Access Compliance Report

Public Rights-of-Way

(Curb Ramps)

Intersection ID: 13650	Main Street: PARK_DR	Cross Street: N_TORRENCE_ST	Location: SW
ADA ID: 792250940964	Ramp Type: Perp	Initial Pass/Fail: Fail	Overall Compliance: No
Severity Score: 12.5			
Codes/Mitigation Info/Possible Solution		Field Measurements/Component Compliance

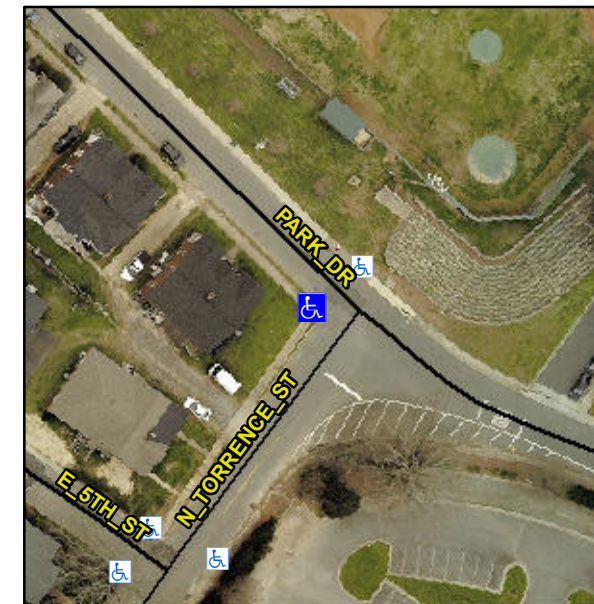
R304.2.2

Compliance	Description	Data	Compliance	Description	Data
N/A	Ramp Length (in)	51.0	No	Ramp Slope (%)	9.2
Yes	Ramp Width (in)	80.0	Yes	Ramp XSlope (%)	1.6
N/A	Flare Type LT	N/A	N/A	Flare Type RT	N/A
N/A	Flare Slope LT (%)	N/A	N/A	Flare Slope RT (%)	N/A
N/A	Flare Traversable LT?	N/A	N/A	Flare Traversable RT?	N/A
N/A	Landing Length (in)	N/A	N/A	DWS Provided?	N/A
N/A	Landing Width (in)	N/A	N/A	DWS Contrast?	N/A
N/A	Landing Slope (%)	N/A	N/A	DWS Length (in)	N/A
N/A	Landing X Slope (%)	N/A	N/A	DWS Full Width?	N/A
N/A	Landing Curb? (Y/N)	N/A	N/A	DWS Offset (in)	N/A
N/A	Shared Landing?	N/A			
N/A	Gutter Ponding?	N/A	N/A	Gutter Slope (%)	N/A
N/A	Gutter Lip Ht (in)	1.0	N/A	Gutter X Slope (%)	N/A
N/A	Painted X Walk1?	No	N/A	Painted X Walk2?	N/A
	X Walk 1 Direction	To NE		X Walk 2 Direction	N/A
N/A	X Walk 1 Width (in)	N/A	N/A	X Walk 2 Width (in)	N/A
	X Walk 1 Slope (%)	1.1		X Walk 2 Slope (%)	N/A
	X Walk 1 X Slope (%)	5.9		X Walk 2 X Slope (%)	N/A

Remove & Replace Entire Ramp.
